IA-32 Intel[®] Architecture Software Developer's Manual

Documentation Changes

November 2003

Document Number: 252046-006

Figure 3.6. Operation of the PACKSSDW Instruction Using 64-bit Operands

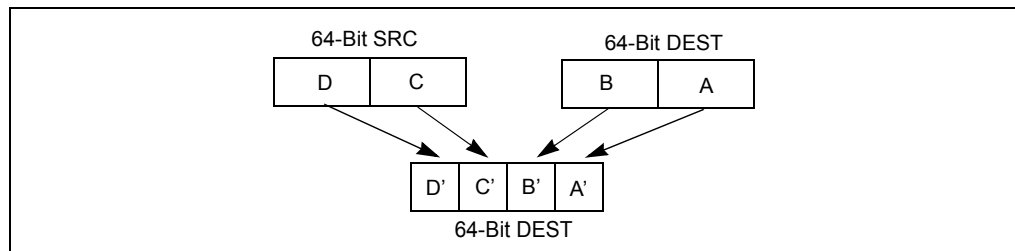
8. Corrected an Error in PACKSSDW Illustration

Operation of the PACKSSDW instruction was incorrectly illustrated in Figure 3-6, the “PACKSSWB/PACKSSDW—Pack with Signed Saturation” section, Chapter 3, *IA-32 Intel Architecture Software Developer’s Manual, Volume 2*.

The corrected figure is reproduced below.

Figure 3-20. Format of Page-Directory-Pointer-Table, Page-Directory, and Page-Table Entries for 4-KByte Pages with PAE Enabled

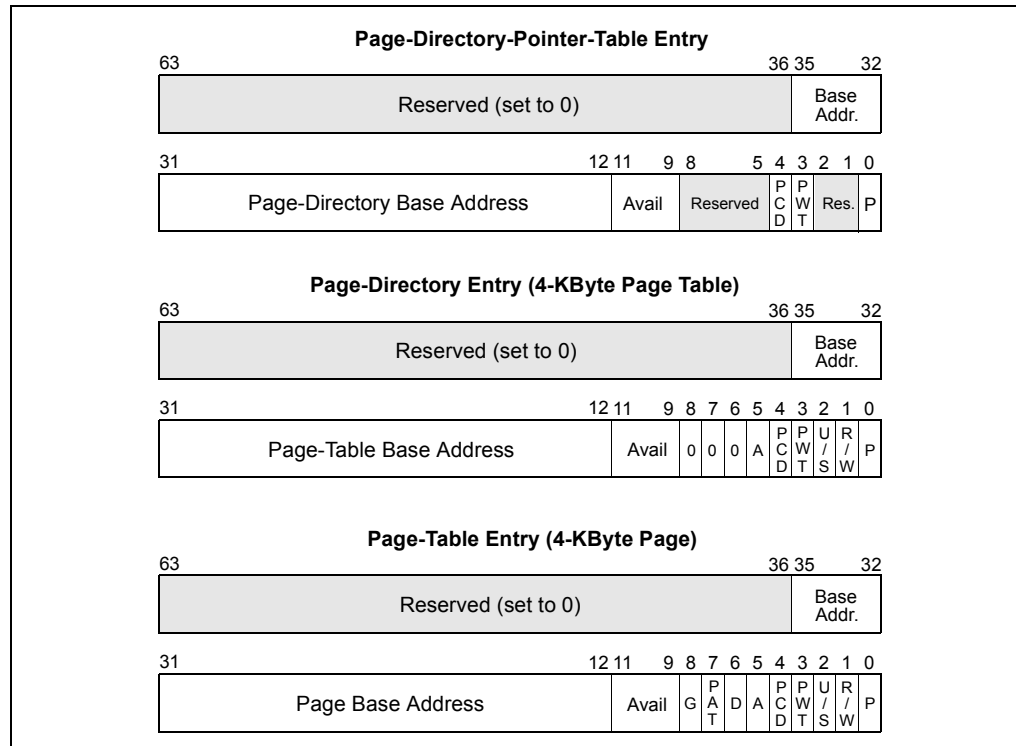
14. Corrections to Page-Directory-Pointer-Table Entry Description

In Figure 3-20 and 3-21, located in the “Page-Directory and Page-Table Entries With Extended Addressing Enabled” section, Chapter 3, *IA-32 Intel Architecture Software Developer’s Manual, Volume 3*; Bit 0 of both representations of the Page-Directory-Pointer-Table Entry now indicate P (showing the the location of the ‘present flag’ bit).

The corrected tables are reproduced below.

Figure E-1. IA32_MCi_STATUS Encoding for Family 06H

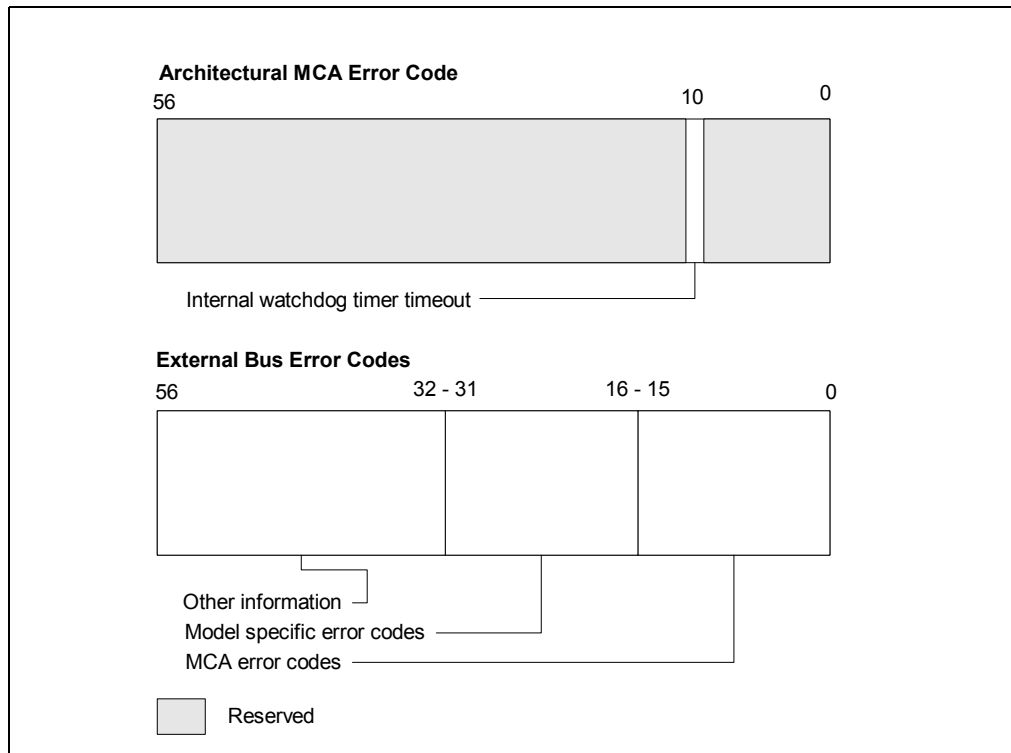
In Volume 3, Appendix E has been re-written to incorporate new IA32_MCi_STATUS data. Encoding of the model-specific and other information fields is different for the 06H and 0FH processor families. Changes are documented in the following sections.

Machine error code reporting by processor family 06H is based on values read from IA32_MCi_STATUS (Figure E-1).

Figure E-2. IA32_MCI_STATUS Encoding for Family 0FH

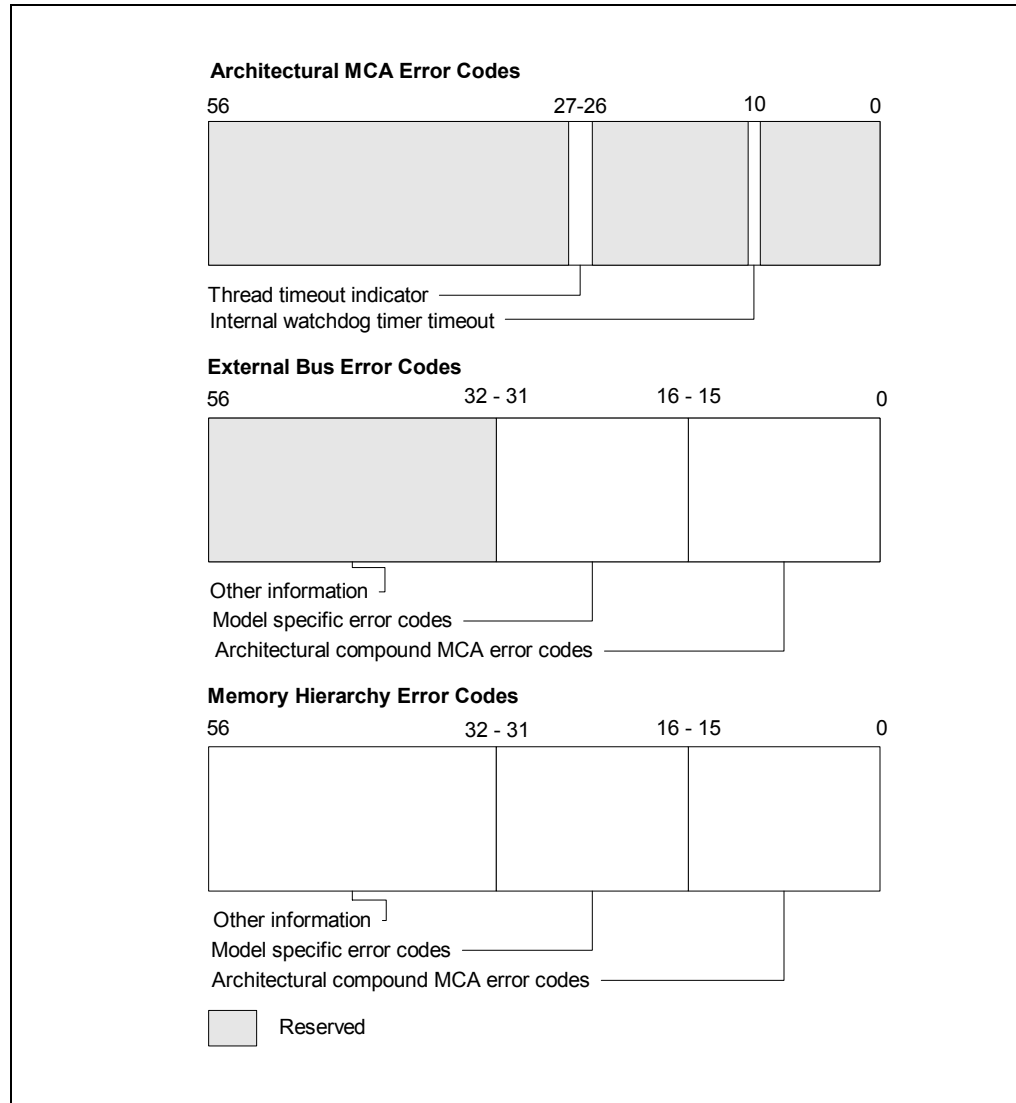
Machine error code reporting by processor family 0FH is also based on values read from IA32_MCI_STATUS (Figure E-2).

Figure 15-3. MSR_LASTBRANCH_TOS MSR Layout for the Pentium 4 and Intel Xeon Processor Family

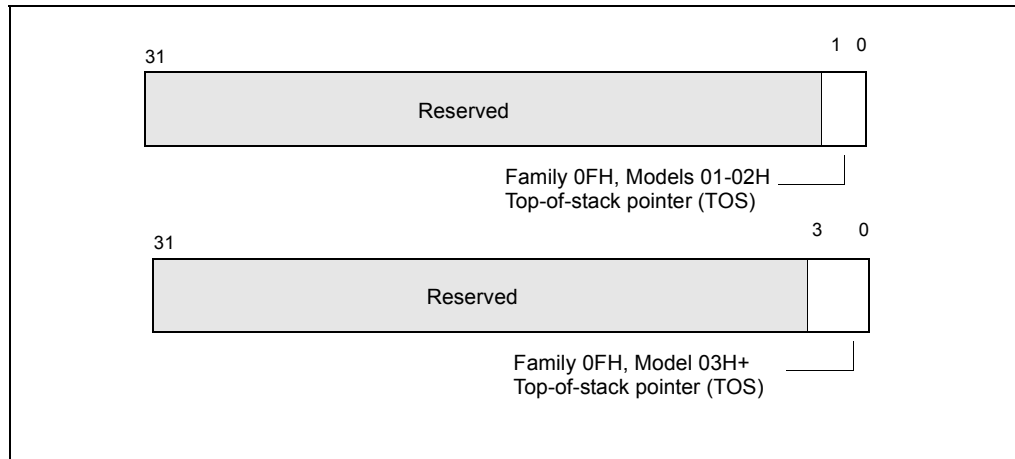
The following information has been added to Volume 3 of the IA-32 Intel Architecture Software Developer's Manual, Section 15.5. This information describes the LBR stack and MSR_LASTBRANCH_TOS

See also: Table 15-2, Figure 15-3, and Figure 15-4 below.

Figure 9-7. Applying Microcode Updates

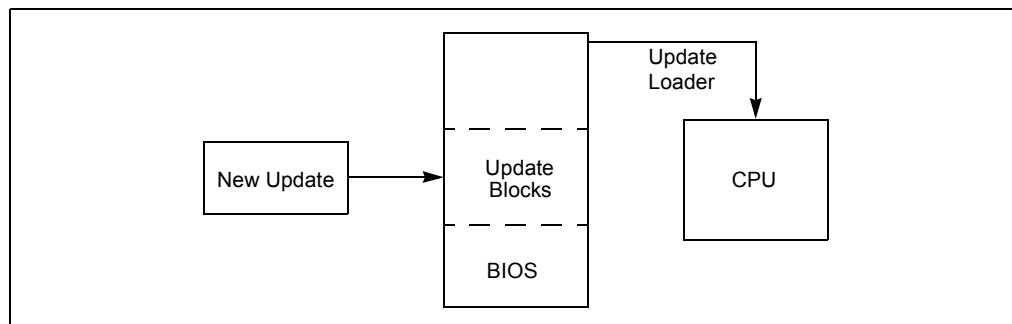
Volume 3 of the IA-32 Intel Architecture Software Developer's Manual, Section 9.11 has been updated. The new information has been added that documents the microcode update facilities added on new processors.

Figure 9-8. Microcode Update Write Operation Flow [1]

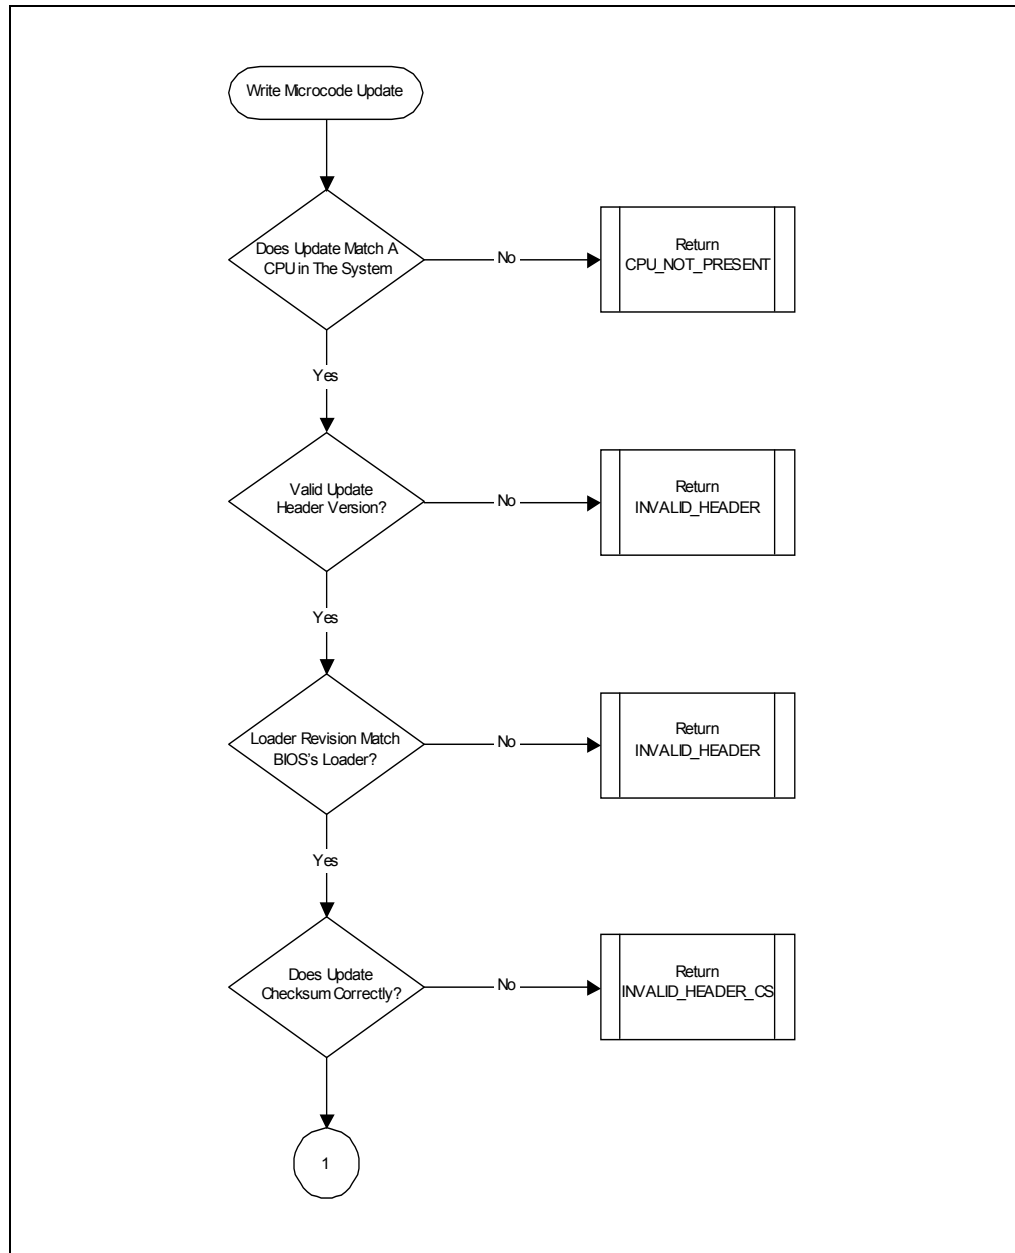
Figure 9-8 and Figure 9-9 show the process the BIOS follows to choose an update block and ensure the integrity of the data when it stores the new microcode update.

Figure 8-20. IRR, ISR and TMR Registers

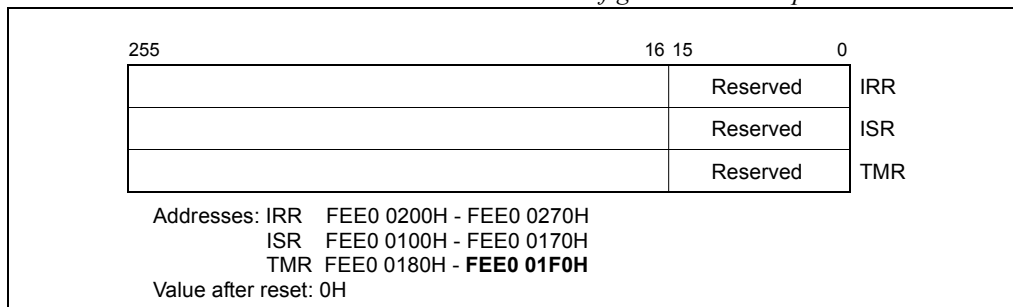
28. Figure 8-22 Has Been Corrected

In Volume 3 of the IA-32 Intel Architecture Software Developer's Manual, Chapter 8, Figure 8-22; an incorrect address has been corrected. The corrected figure has been reproduced below.
